Access Compliance Report

Public Rights-of-Way

Intersection ID: 11773	Main Street: S CEDAR ST	Cross Street: S CLARKSON ST	Location: N
ADA ID: FEB4B196E591	Ramp Type: PerpDiag	Initial Pass/Fail: Fail	Overall Compliance: No
Severity Score: 12.5			
Codes/Mitigation Info/Possible Solution		Field Measurements/Component Compliance

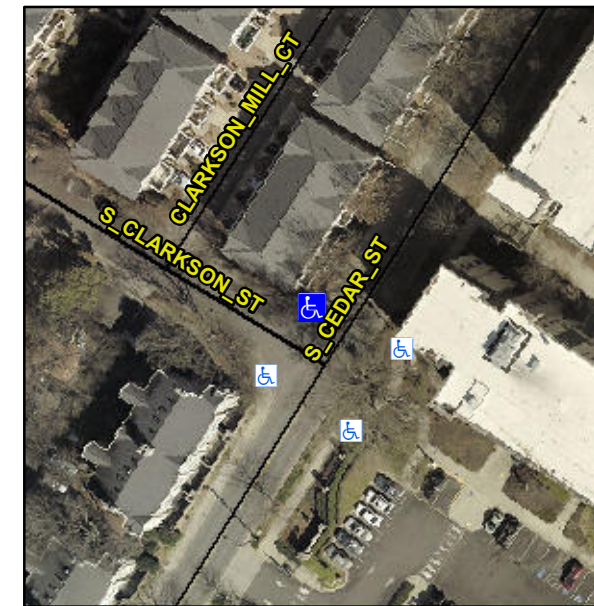
Not Found, R304.5.3

Compliance	Description	Data	Compliance	Description	Data
N/A	Ramp Length (in)	64.0	Yes	Ramp Slope (%)	8.2
Yes	Ramp Width (in)	54.0	No	Ramp XSlope (%)	5.6
N/A	Flare Type LT	N/A	N/A	Flare Type RT	N/A
N/A	Flare Slope LT (%)	N/A	N/A	Flare Slope RT (%)	N/A
N/A	Flare Traversable LT?	N/A	N/A	Flare Traversable RT?	N/A
N/A	Landing Length (in)	N/A	N/A	DWS Provided?	N/A
N/A	Landing Width (in)	N/A	N/A	DWS Contrast?	N/A
N/A	Landing Slope (%)	N/A	N/A	DWS Length (in)	N/A
N/A	Landing X Slope (%)	N/A	N/A	DWS Full Width?	N/A
N/A	Landing Curb? (Y/N)	N/A	N/A	DWS Offset (in)	N/A
N/A	Shared Landing?	N/A			
N/A	Gutter Ponding?	N/A	N/A	Gutter Slope (%)	N/A
N/A	Gutter Lip Ht (in)	N/A	N/A	Gutter X Slope (%)	N/A
N/A	Painted X Walk1?	No	N/A	Painted X Walk2?	No
	X Walk 1 Direction	To SW		X Walk 2 Direction	To SE
N/A	X Walk 1 Width (in)	N/A	N/A	X Walk 2 Width (in)	N/A
	X Walk 1 Slope (%)	0.2		X Walk 2 Slope (%)	4.8
	X Walk 1 X Slope (%)	3.9		X Walk 2 X Slope (%)	1.5

Remove & Replace Curb Ramp With Two New Directional Ramps or Equivalent.
